Buncombe County Planning Board April 18, 2016

SUB2016-00117: Gary Davis from Davis Civil Solutions sought major subdivision approval for an 18 lot subdivision located on tax lot PINs 9635.61.8385, 9635.61.8502, 9635.61.6378 & 9635.71.0522 (144, 145, 147 & 149 Clayton Road).

Buncombe County Planning Board Meeting Recommended Staff Conditions April 18, 2016 **SUB2016-00117** Weatherwood Subdivision

Site Development Plan For Weekeed State Development Plan For Plan For Weekeed State Development Plan For Weekeed State Development Plan For Weekeed State Development Plan For Pl

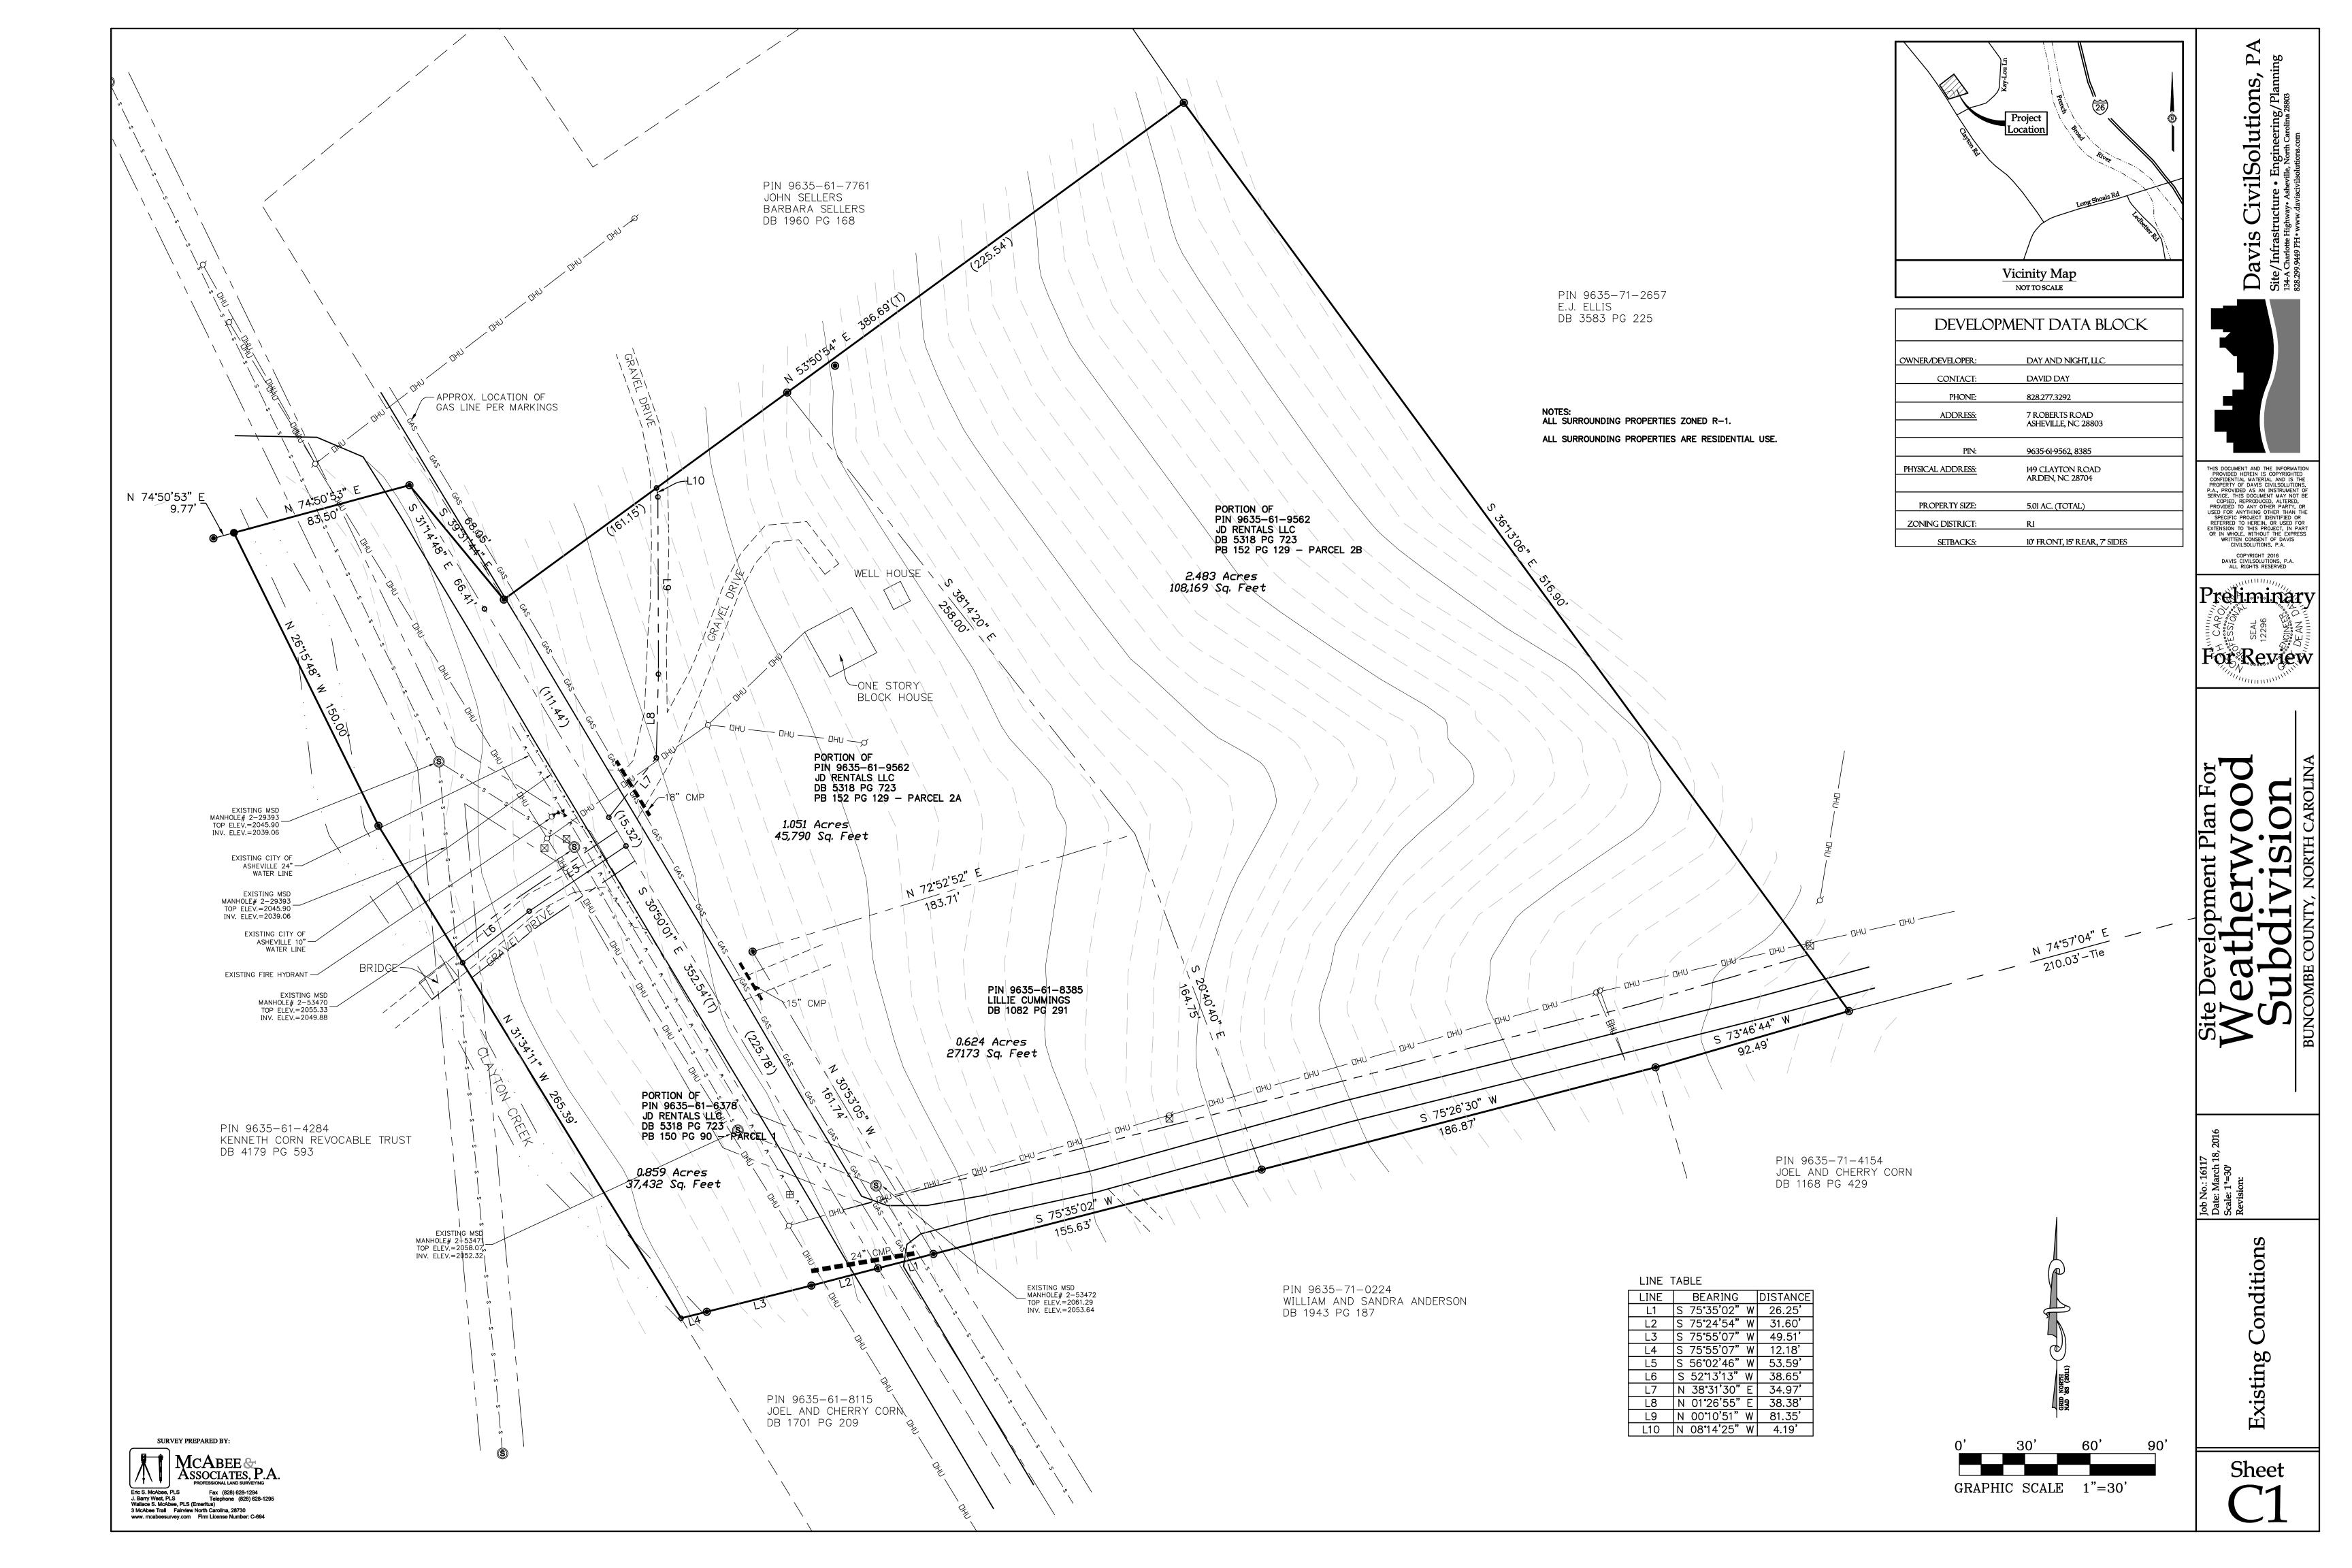
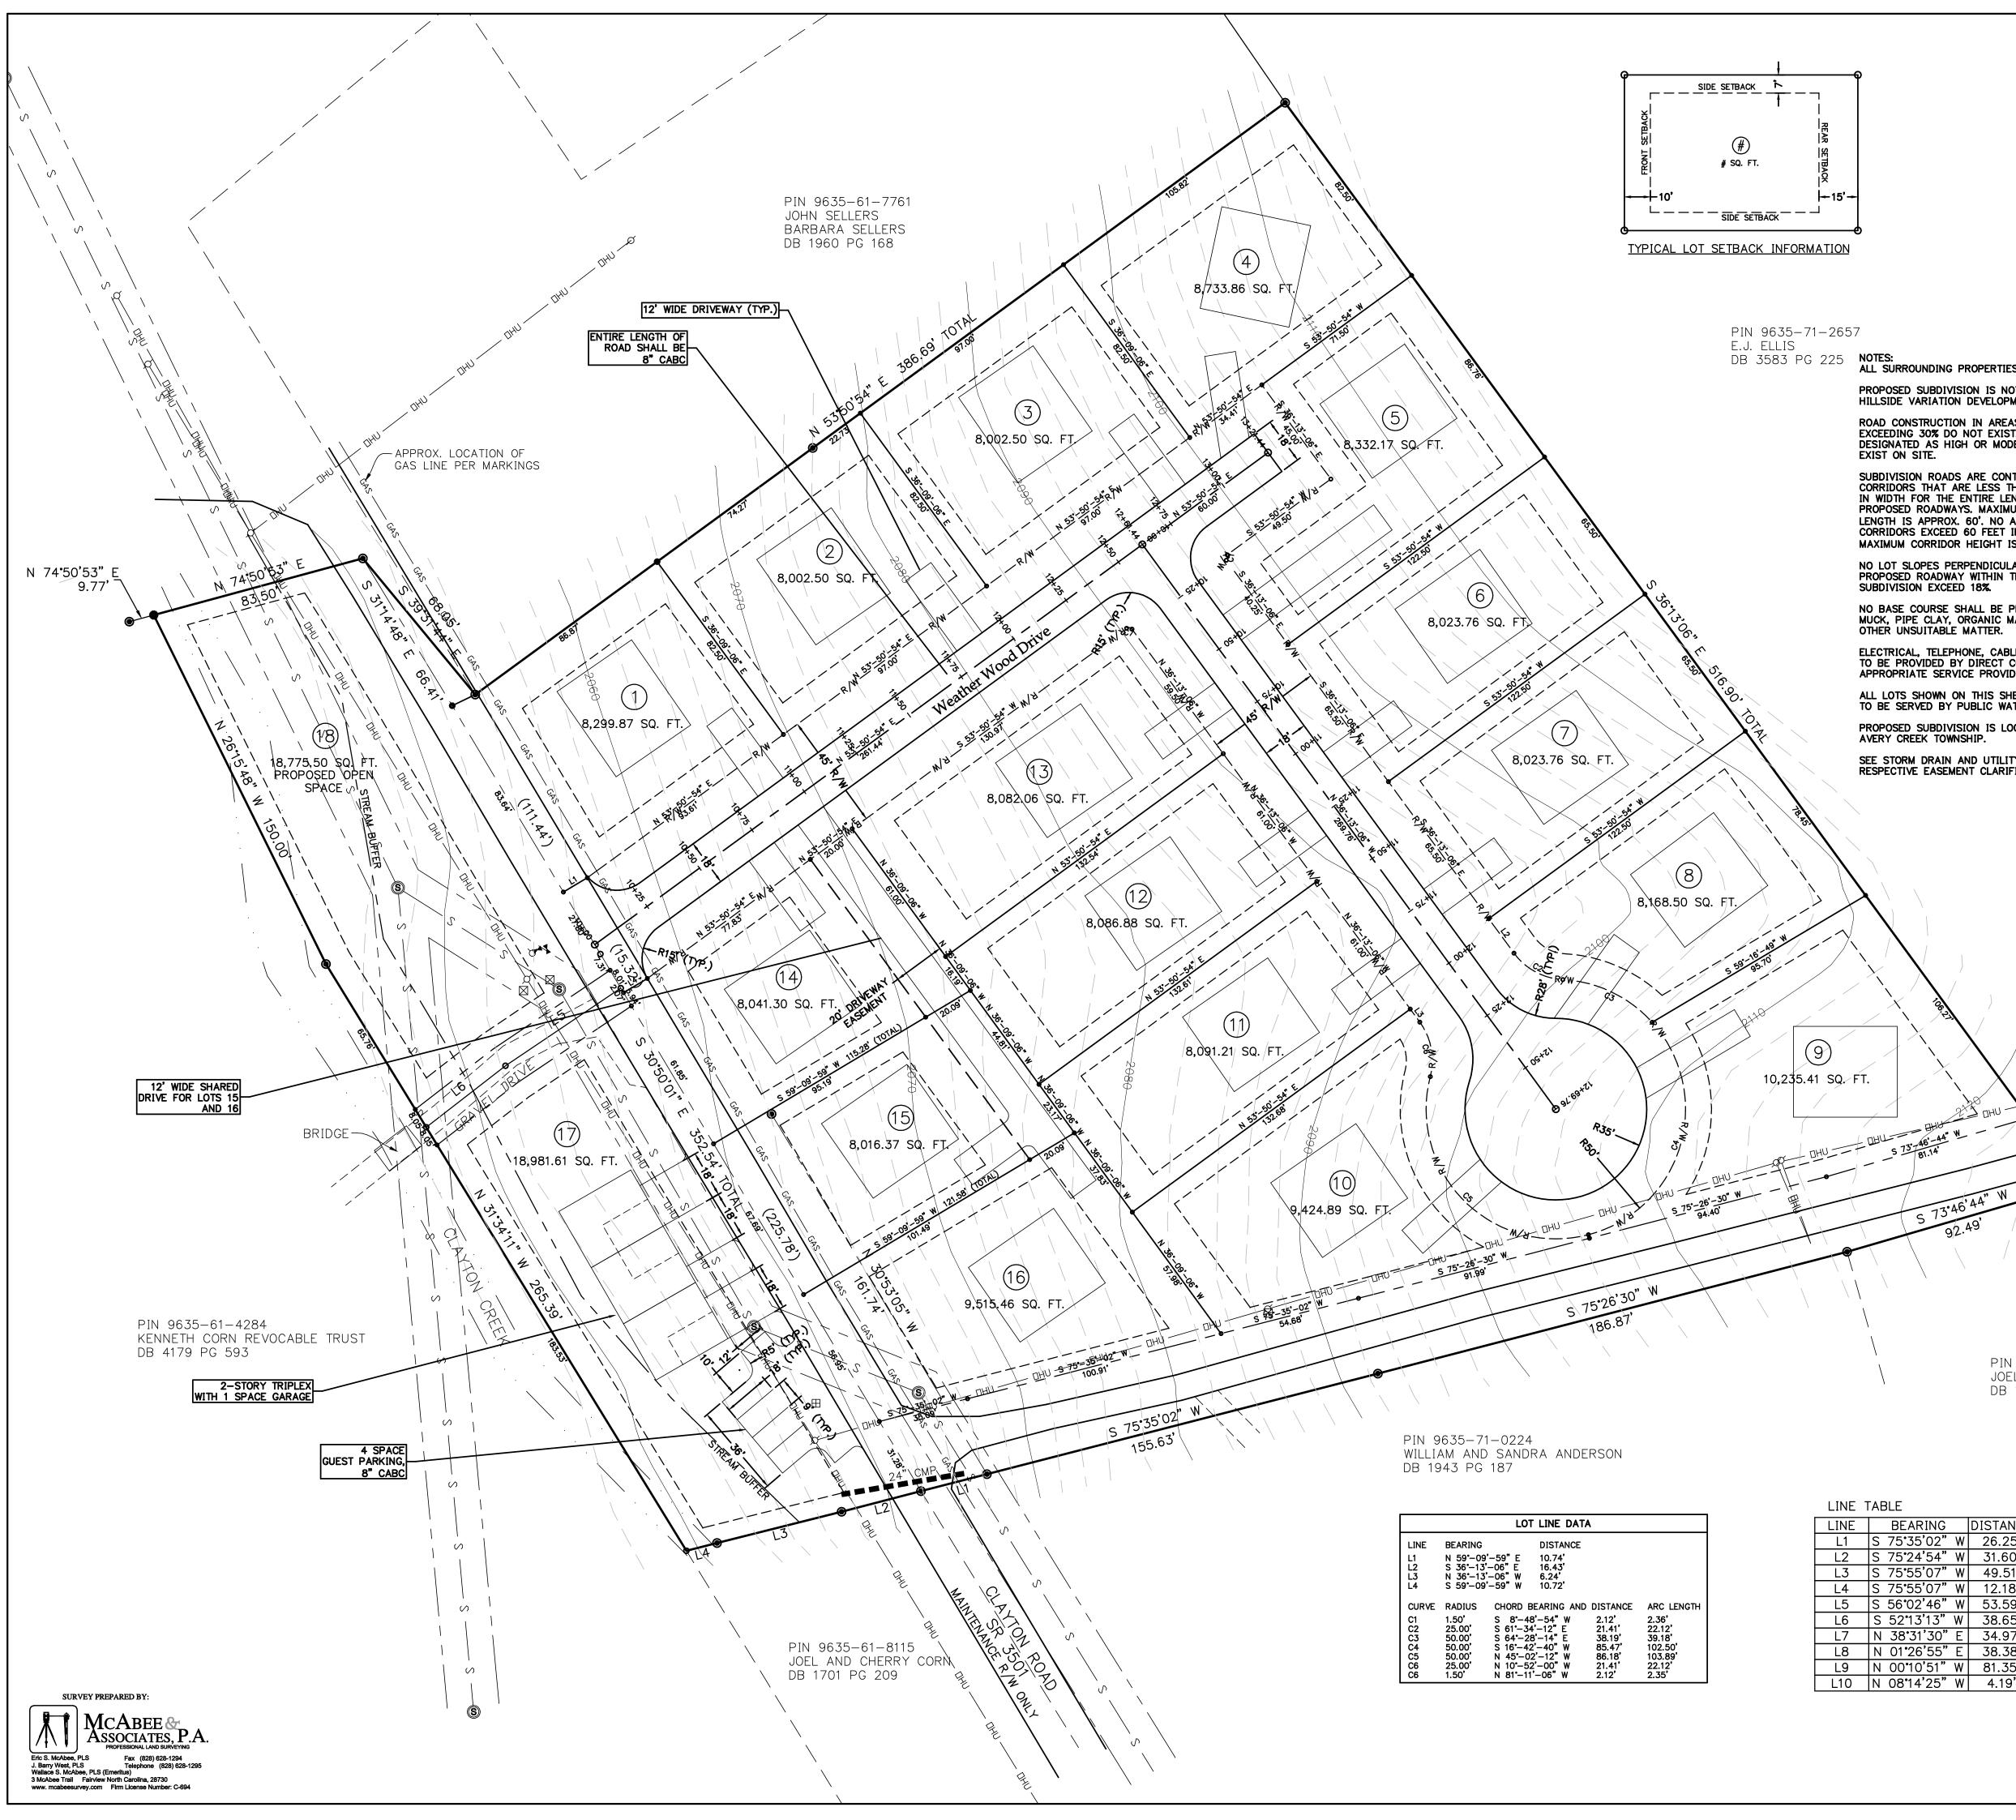
- 6. Indicate on revised plans that two feet of additional drivable surface will be provided on the roads within the subdivision capable of supporting a fire apparatus weighing at least 75,000 pounds.
